CITY OF ALBUQUERQUE

RE: **Juan Tabo Hills Park**
Grading and Drainage Plan for SPBP – Disapproved
Engineer's Stamp Date: 7/16/2018 (M22D017A)

JUAN TABO HILLS PARK – PHASE 1

ISAACSON & ARFMAN, P.A.
Consulting Engineering Associates
128 Monroe Street N.E.
Albuquerque, New Mexico 87108
Ph. 505-268-8828 www.iacivil.com
2236 CG-101.dwg Jul 16, 2018

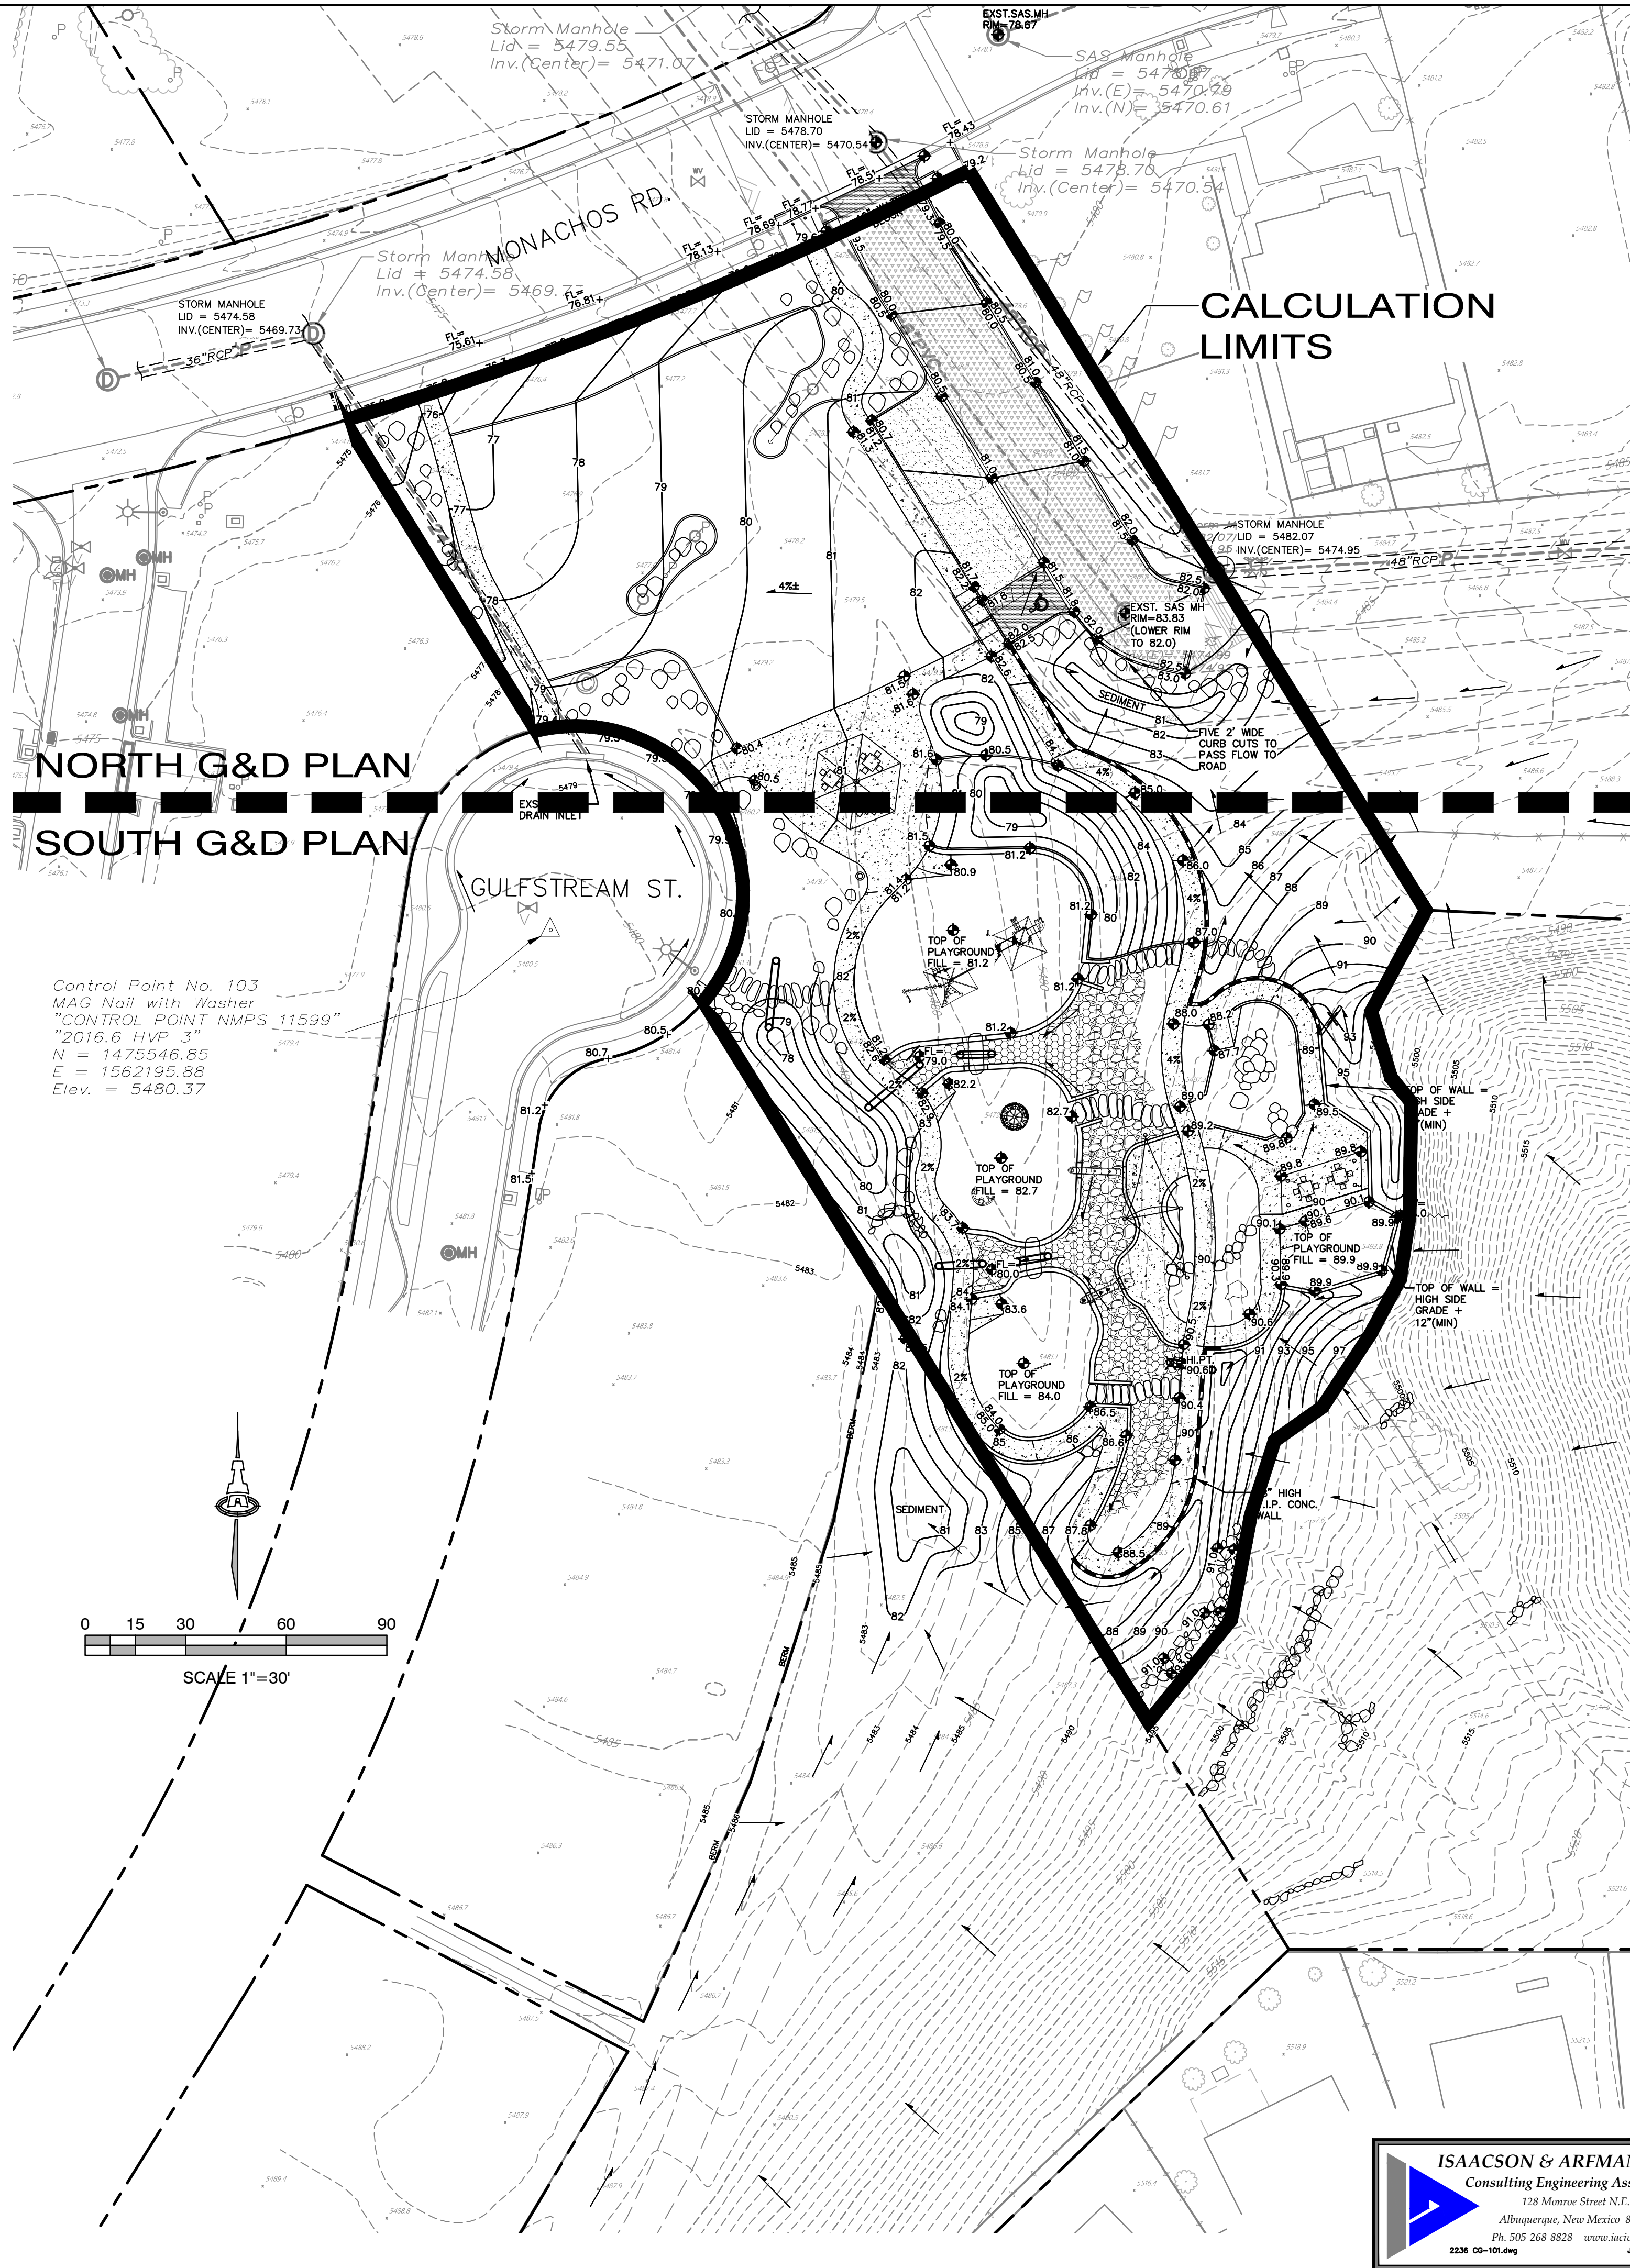
1. A Drainage Management Plan narrative must be added stating whether this site is providing Detention, Retention, or Free Discharge. Capacity calculations are required on Monachos Rd. from this site to Juan Tabo Blvd. and if Monachos Rd. doesn't have capacity for surface drainage then the Public Storm drain may be extended into the site to be accompanied by HGL analysis. This is not just a matter of limiting the discharge to "Historic" flow rate. Infrastructure will be required if the flow from this site exceeds downstream capacity.

2. The layout must be revised so that the swale on the southwest side of the site remains unobstructed. The Playground includes more than 3' of fill in the swale, which may force drainage from the swale into the private lots west of the park. The playground may need to be shifted east to avoid blocking the swale. Capacity calculations are required for the swale, and must include 1' of freeboard.

3. Either provide written permission from the owner of the lot to the southwest for the grading that is shown on their property or delete the grading from the plan. Volume calculations and a Drainage Covenant are required for the pond if it remains on the G&D Plan.

4. The Gulf Stream cul-de-sac was not originally designed to receive any drainage from this site, but it may have extra capacity for some of the drainage from the pond just east of the Cul-de-sac. Pond design calculations are required, including an emergency overflow path. If the path is into the cul-de-sac then the capacity of the downstream system must be checked.

5. Capacity calculations are needed for the swale running down the west side of the park between the Gulf Stream cul-de-sac and Monachos Rd. to insure that drainage does not cross into the private lot west of the park.

6. The Volterra Village Drainage Report dated 9-30-2009 by Greg Krenik shows 13.48 cfs in the storm drain from the Gulf Stream cul-de-sac and 21.89 cfs from the "Open space Pond". That report was later modified by a G&D plan and calculations dated 10/31/2012 and 1/7/2013 respectively from Diane Hoelzer. The engineer responsible for this G&D plan may find these reports helpful but additional calculations will be required, including accounting for split flow at intersections in Volterra Village where water blocks were not constructed, and partial interception at the inlets.
7. Prior to Certificate of Occupancy an Engineer's Certification per the DPM checklist will be required.
